ECR#: P24

Title: I/O Connector Area Definition

Spec Version: NLX Motherboard Specification V1.2

Figure 3.17: Chassis Back Panel I/O Shield Opening

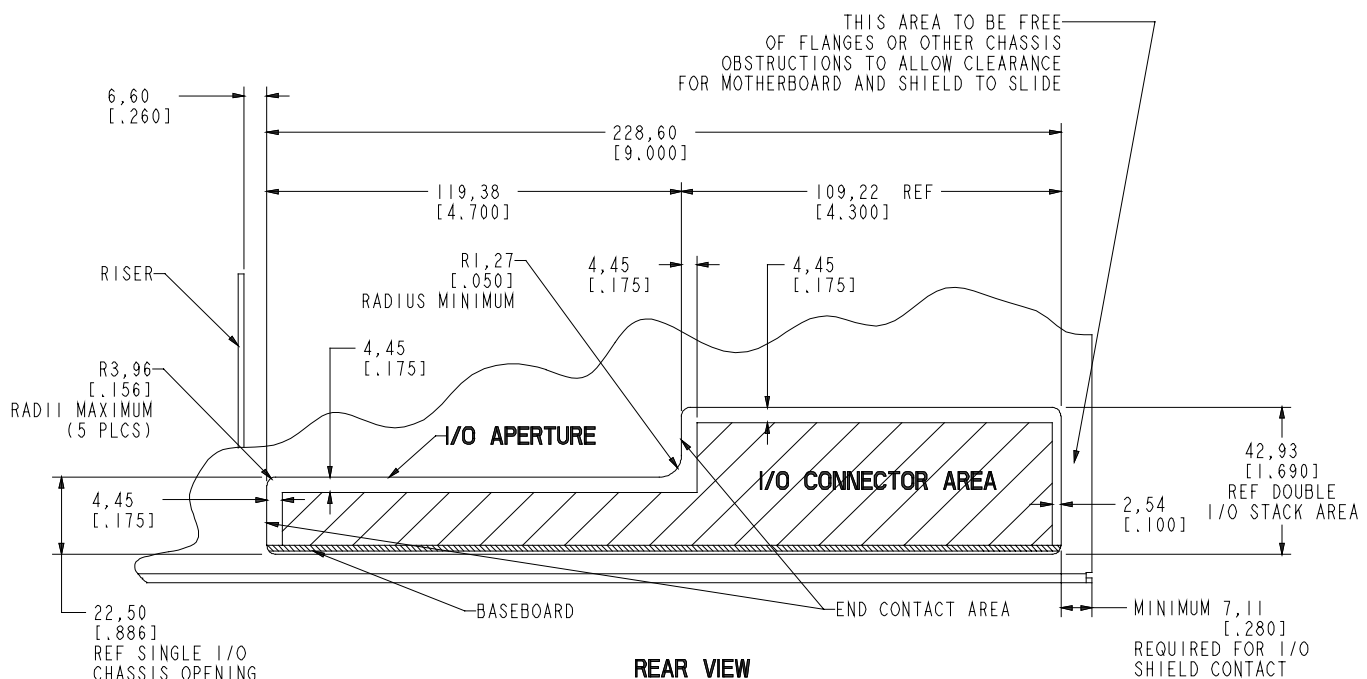
In Section 3.9.1, **replace** the existing figure with the modified figure provided here. Note: This figure also incorporates the changes recommended in ECR# P1.

However, this specification does limit placement of the I/O connector to this extent: The motherboard supplier must ensure that there is sufficient clearance between the I/O connector, the connector housing, and the chassis to allow sufficient material in the I/O shield to make proper contact.
